UNITED STATES PATENT AND TRADEMARK OFFICE

APPLICATION NO.	FILING DATE	FIRST NAMED INVENTOR	ATTORNEY DOCKET NO.	CONFIRMATION NO.
10/525,864	02/25/2005	Mark Hanlon	100918.0001US	2186
34284	7590	06/19/2007		
Rutan & Tucker, LLP. Hani Z. Sayed 611 ANTON BLVD SUITE 1400 COSTA MESA, CA 92626			EXAMINER LANGDON, EVAN H	
			ART UNIT	PAPER NUMBER
			3654	
			MAIL DATE	DELIVERY MODE
			06/19/2007	PAPER

Office Action Summary

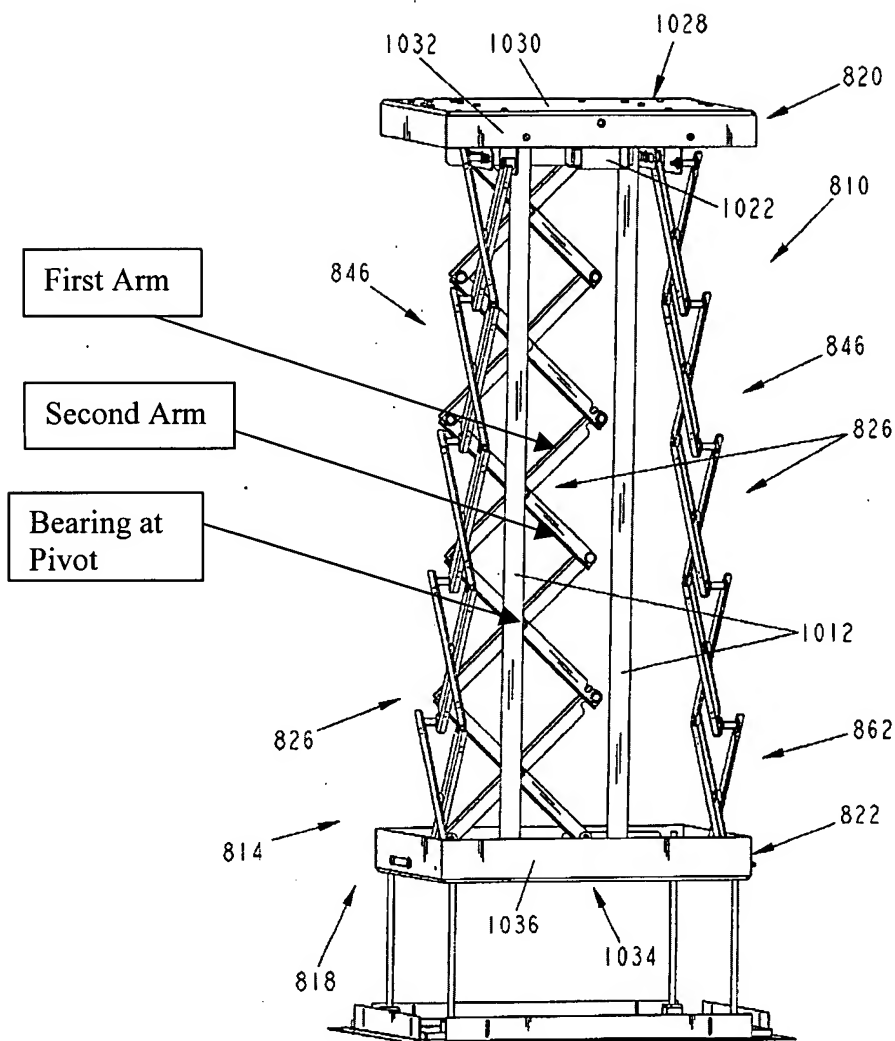
a stabilizer 826 having a first arm and a second arm (Fig. 32 and 36, see below), such stabilizer disposed between the support frame 1028 and the lifting platen 1034, and disposed relative to the panels to prohibit motion in all but one plane.

In regards to claims 2, Enchos discloses the stabilizer comprises a bearing at a pivot (see above, Fig. 39) joining the first and second arms.
